DRAWN & DRAFTED BY	LIU YOU SEN	TOLERANCES	ANGLE: $\pm 1^\circ$	TITLE:	BOBBIN BP-E28P
CHECKED & APPROVED BY		$0 < L \leq 4 \pm 0.1$ $4 < L \leq 16 \pm 0.2$ $16 < L \leq 63 \pm 0.3$	UNIT: MM	BOBBIN MATERIAL:	UL REC.
		pin pitch ± 0.2	ORIGIN: SZ	PHENOLIC PM9820	UL 94V-0
				PIN MATERIAL:	PIN TENSION LOAD:
				CP WIRE	2.0kg MIN.
				DATE:	DRAWING NO.
				AUG.28 '2003	P-2818
					REV. 5

PIN SHINE INDUSTRIAL CO., LTD.

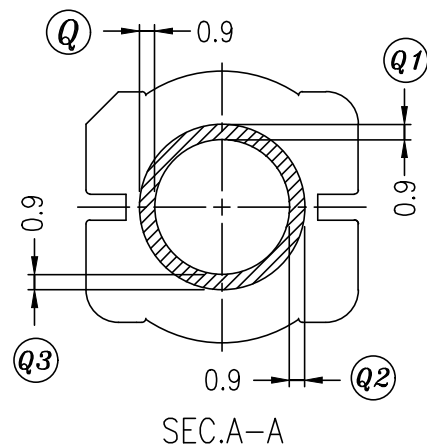
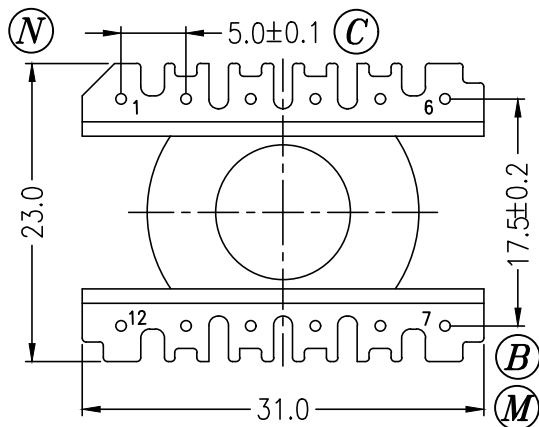
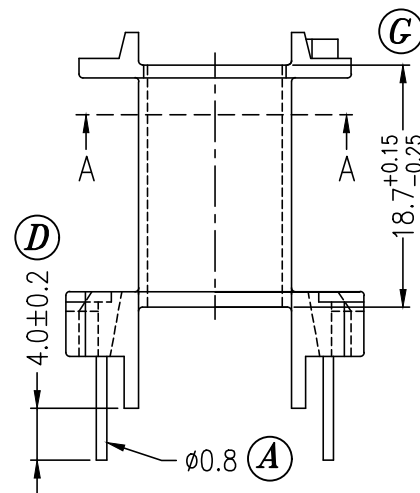
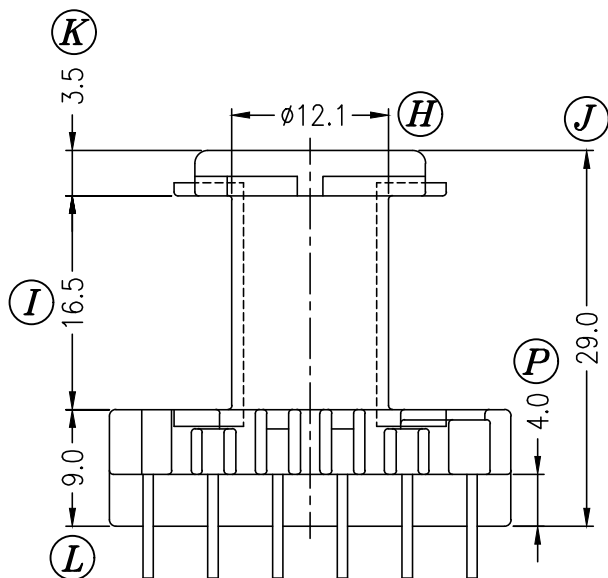
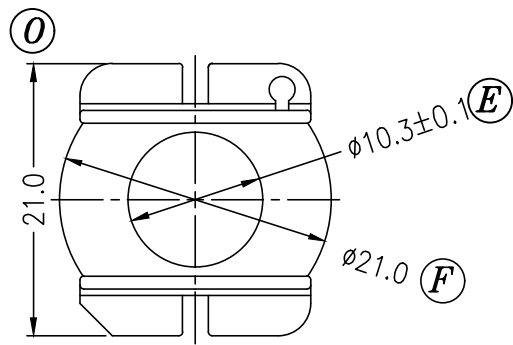
REV.	REVISIONS	REC.	REV.	REVISIONS	REC.
4	頂部的凸點與擋牆處連接起來，鐵芯長度由 18.7 ± 0.1 改為				
	$18.7 + 0.15 / - 0.25$ ，壁厚由 0.9 ± 0.05 改為 0.9				
5	(E): $10.3 + 0.1 / - 0 \rightarrow 10.3 \pm 0.1$
